HANFORD FEDERAL FACILITY AGREEMENT AND CONSENT ORDER CHANGE CONTROL FORM C-93-1, CONSOLIDATE OPERABLE UNITS (OUs) 100-DR-2 AND 100-DR-3

HANFORD FEDERAL FACILITY AGREEMENT AND CONSENT ORDER  
CHANGE REQUEST

Change Number <b>C-93-1</b>	<b>Federal Facility Agreement and Consent Order Change Control Form</b> <small>Do not use blue ink. Type or print using black ink.</small>	Date <b>02/03/94</b>
Originator <b>G. I. Goldberg</b>		Phone <b>376-9552</b>
Class of Change <input type="checkbox"/> I - Signatories <input checked="" type="checkbox"/> II - Project Manager <input type="checkbox"/> III - Unit Manager		
Change Title <b>CONSOLIDATE OPERABLE UNITS 100-DR-2 AND 100-DR-3</b>		
Description/Justification of Change <ol style="list-style-type: none"> <li>1. Change the 100-DR-2 Operable Unit (OU) boundary to include the 100-DR-3 OU waste sites. The U.S. Department of Energy, Richland Operations Office, U.S. Environmental Protection Agency, and the State of Washington Department of Ecology, agree that consolidating the 100-DR-3 OU into the 100-DR-2 OU will allow for a more efficient and effective limited field investigation (LFI) of the remaining 100-DR reactor area waste sites.</li> <li>2.

ORIGINAL BOUNDARIES OF THE 100-DR-2 AND 100-DR-3 OPERABLE UNITS

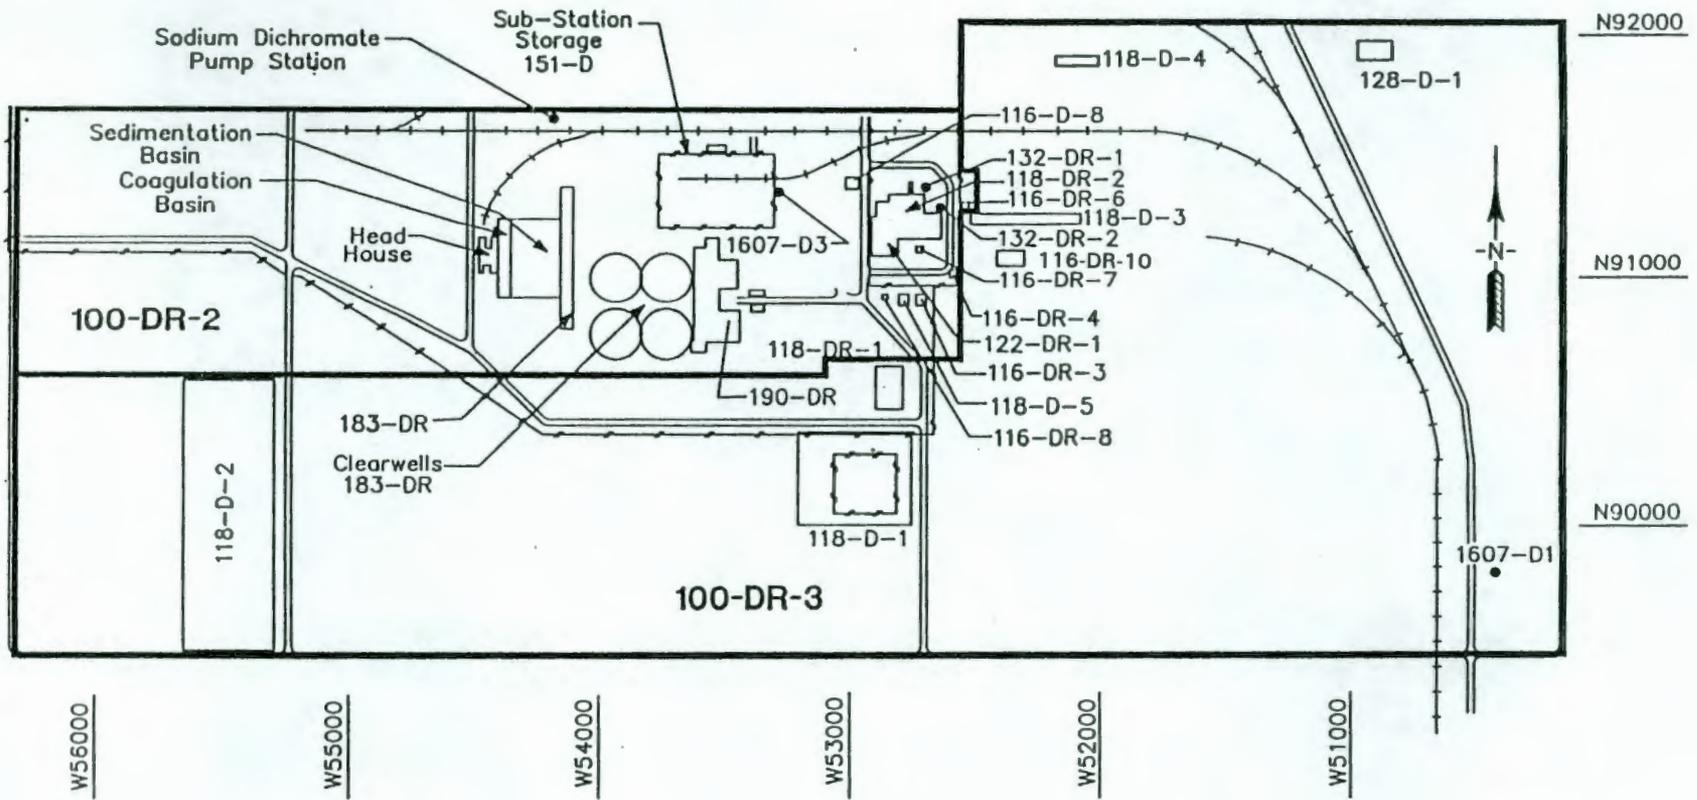
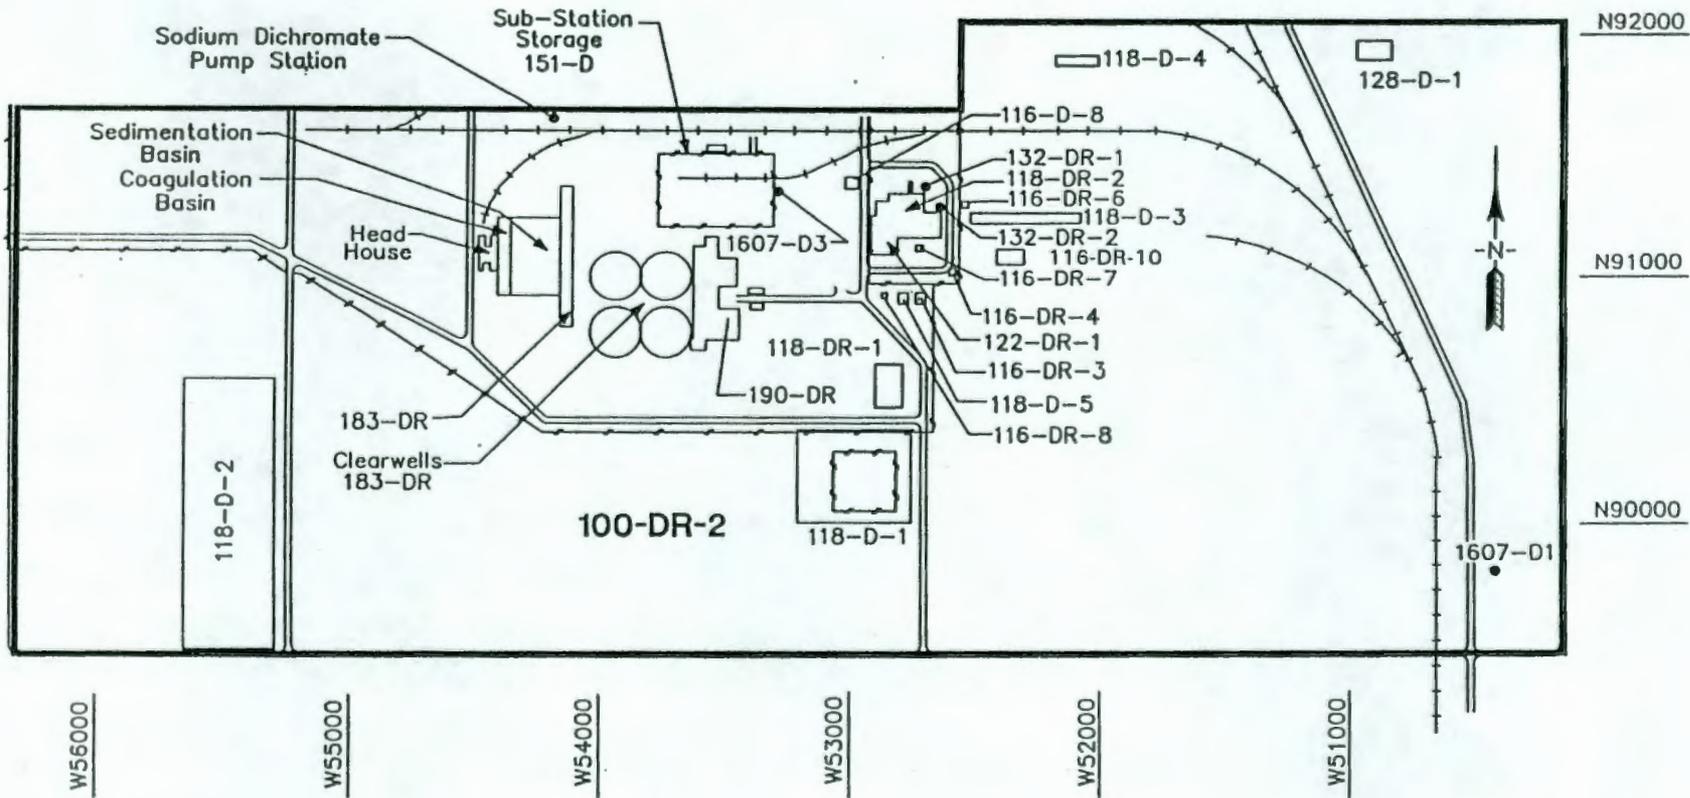
Enclosed for your approval is the draft Class II Hanford Federal Facility Agreement and Consent Order Change Control Form, Consolidate Operable Units 100-DR-2, and 100-DR-3. The purpose of this change request is to redefine the 100-DR-2 OU boundaries to include the waste sites associated with the 100-DR-3 OU. This will require the removal of the 100-DR-3 OU from the Hanford Federal Facility Agreement and Consent Order, allowing the 100-DR-3 Area source waste sites to be addressed as part of the limited field investigation for the 100-DR-2 OU. This consolidation will result in achieving more efficient and cost effective remediation in the 100 Area OUs. Also enclosed are Description of Sites Associated with the New 100-DR-2 OU, Original Boundaries of the 100-DR-2 and 100-DR-3 OUs, and Boundary of 100-DR-2 OU after inclusion of 100-DR-3 OU.

Impact of Change None. References to OU 100-DR-3 will be removed from the Tri-Party Agreement or changed to reflect the enlarged 100-DR-2 OU as necessary.		
Affected Documents <u>Hanford Federal Facility Agreement and Consent Order Action Plan, Appendices C and D</u> <u>Preliminary OU Designation Project, WHC-EP-0216</u> <u>Hanford Site Waste Information Data System (WIDS)</u>		
Approvals		
_____	Date _____	___ Approved ___ Disapproved
DOE		
_____	Date _____	___ Approved ___ Disapproved
EPA		
_____	Date _____	___ Approved ___ Disapproved
Ecology

BOUNDARY OF 100-DR-2 OPERABLE UNIT AFTER INCLUSION OF  
100-DR-3 OPERABLE UNIT
